Temperature Control Subsystem Wiring

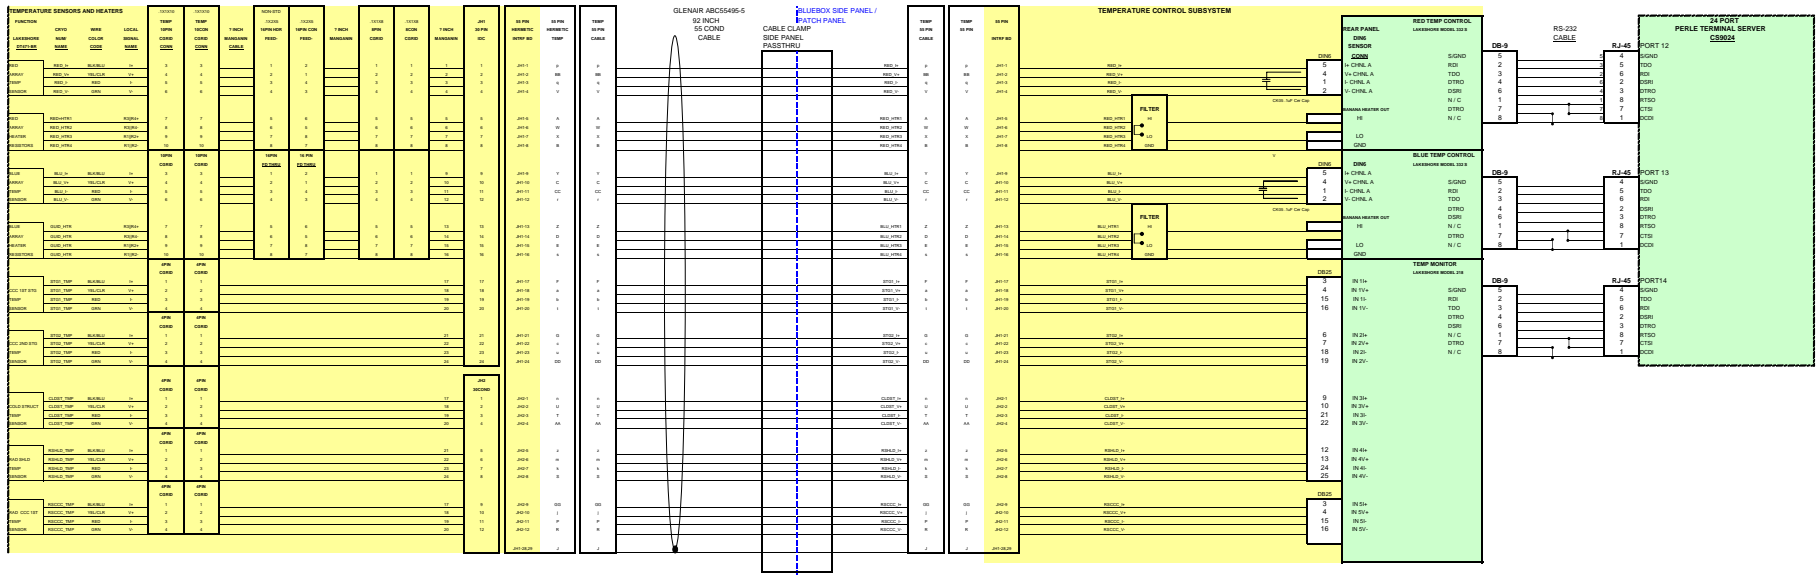
Version Control
v1.2: removed APD Temp Sensor, Added Title
